Office Action Summary	Application No. 10/707,664	Applicant(s) WU ET AL.	
	Examiner Tarifur R. Chowdhury	Art Unit 2871

DETAILED ACTION

4. Claims 1-8 are rejected under 35 U.S.C. 103(a) as being unpatentable over Wang et al., (Wang), USPAT 6,714,268 in view of Muruyama et al., (Muruyama), US 2002/0149320.

FIG. 4

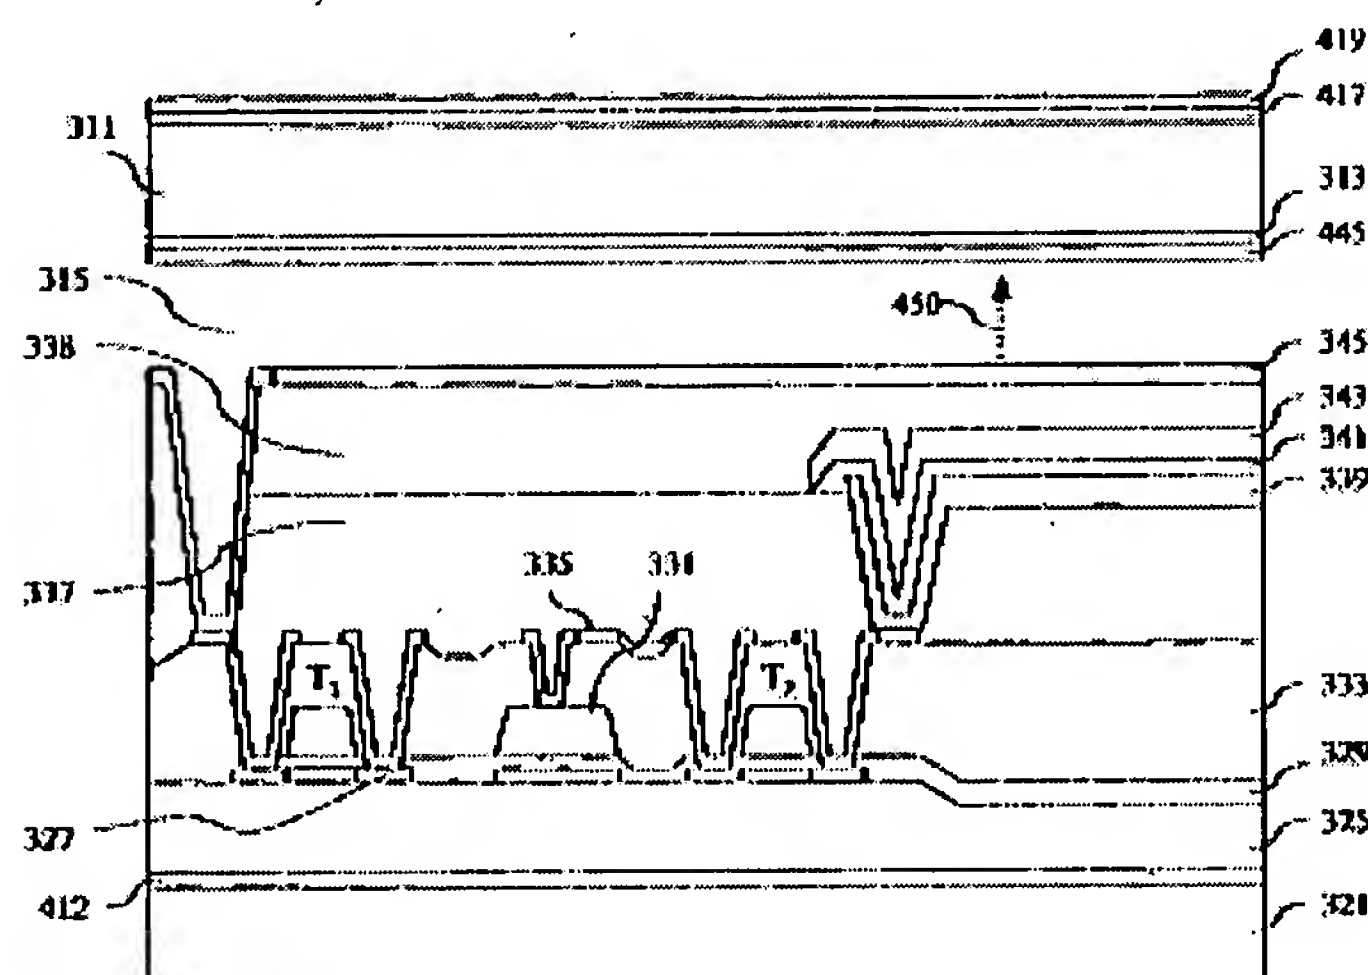
5. Wang discloses and shows in Fig. 4, a dual mode liquid crystal display device, comprising:

- an upper substrate (311);
- a lower substrate (321) comprising a first thin film transistor (T3), a second thin film transistor (T2), an electrode (345) connected to the first thin film transistor (T3), and a regional light-emitting source (combination of layers 339 (anode), 341 (OLED material) and 343(cathode)) connected to the second thin film transistor (T2); and
- a liquid crystal layer (315) between the upper substrate and the lower substrate.

Wang also discloses and shows in Fig. 4 that the light-emitting diode further includes:

- a cathode (343) on the lower substrate;
- a light-emitting layer (341) on the cathode; and
- a second transparent electrode (339) on the light-emitting layer , wherein the second electrode serves as an anode.

Wang further shows that a reflective layer (412) is formed on the lower substrate (321).

Wang differs from the claimed invention because he does not explicitly disclose

that the electrode layer (345) is reflective. However, it is common and known in the art to reduce extra layers and thus obtain a compact and thin device that is lightweight and cheap to manufacture. Further, using a reflective electrode instead of a combination of a reflective layer and an electrode is also common and known. Therefore, it would have been obvious to one of ordinary skill in the art at the time of the invention was made to modify the display device of Wang by eliminating the reflective layer and using a reflective electrode instead of the electrode (345) in order to obtain a compact device that is thin and light weight.

As to claims 2 and 3, Wang also shows in Fig. 4 that the upper substrate of the display device further includes:

- a substrate (311);
- a color-filtering array (313) on one surface of the substrate; and
- a first transparent electrode (445) on the surface of the color-filtering layer;
- a polarizer plate (419) and
- a quarter-wave plate (417) on a substrate surface just opposite the color-filtering array.

As to claim 6, it is clear from Fig. 4 of Wang that the electrode (345) is set up on a layer (338) (applicant's bumpy layer).

As to claims 7 and 8, it is also clear from the disclosure as well as Fig. 4 of Wang that the first thin film transistor (T3) and the electrode (345), the second thin film transistor (T2) and the regional light-emitting source are formed in a pixel region.

In response to applicant's argument that Wang fails to teach or suggest that the transparent electrode 345 and the transparent cathode/anode can be replaced by reflective material, it is respectfully pointed out to applicant that first of all the use of reflective layer (412) suggests to one of ordinary skill in the art that the display can be used in a reflective mode and further as explained in the rejection above that using a reflective electrode instead of a combination of a reflective layer and an electrode is also common and known. Further, as suggested by Muruyama using a reflective cathode is also advantageous. Therefore, since the disclosure of Wang does not teach away from using reflective electrode and reflective cathode and further there is a motivation (see the rejection above) for using reflective material for the electrode and the cathode, one of ordinary skill in the art would desire to modify the display device of Wang for advantages such as obtaining a device that is thin and lightweight as well as provides good luminance and high visibility.
